Design error 2

During the course of the Re-opened Formal Investigation into the loss of the trawler Gaul, the DfT's retained expert noted that there was an error in the draughtsman's calculation regarding the weight of waste that would operate the non-return flaps in the vessel's duff and offal chute discharges.

The draughtsman's calculation:

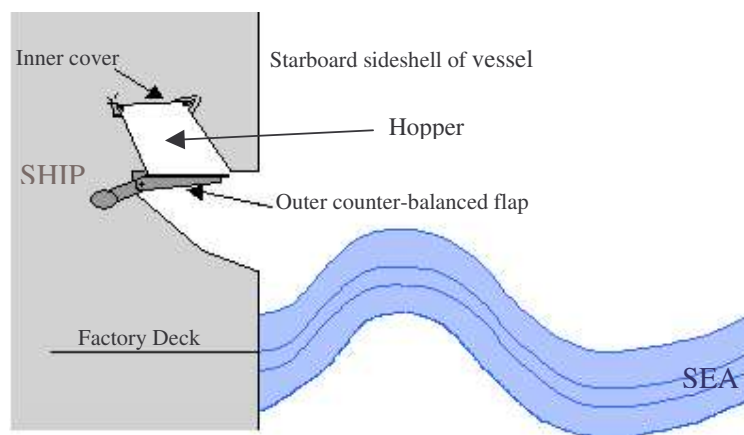
Unfortunately when carrying out this simple calculation, the draughtsman had neglected to include the weight of the steel non-return flap in the equation and, as the non-return flap was positioned on the same side of the hinge as the waste in the hopper, the weight required to open the flap was reduced. After recalculation, it was found that the weight of waste required to initiate discharge was reduced from the designed weight of 51 kg (113 lbs) to about 15 kg.

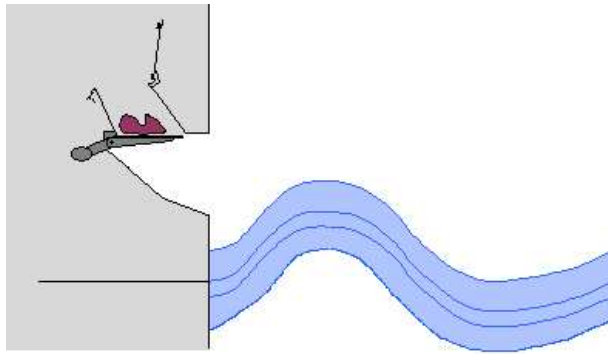
Sketch showing the arrangement of the duff and offal chute discharges, including the hinged inner cover and outer counter-balanced non-return flap - both shown in their closed positions:

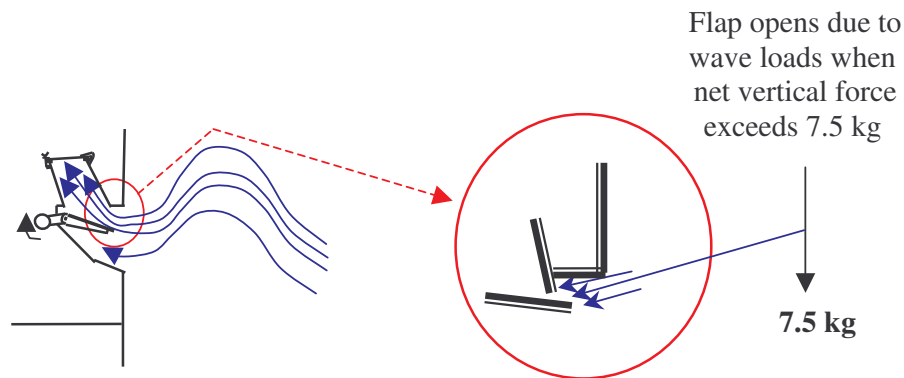
Additionally, this 'self-closing' force of 15 kg, which is provided by the counterbalance weight, is the force that applies at the centre of the non-return flap plate (which is also the centre point of the hopper). Simple moment and lever calculations show that the force required to overcome this 'self-closing' force will be reduced to only 7.5 kg¹ if it is applied at the outboard edge of the non-return flap plate.
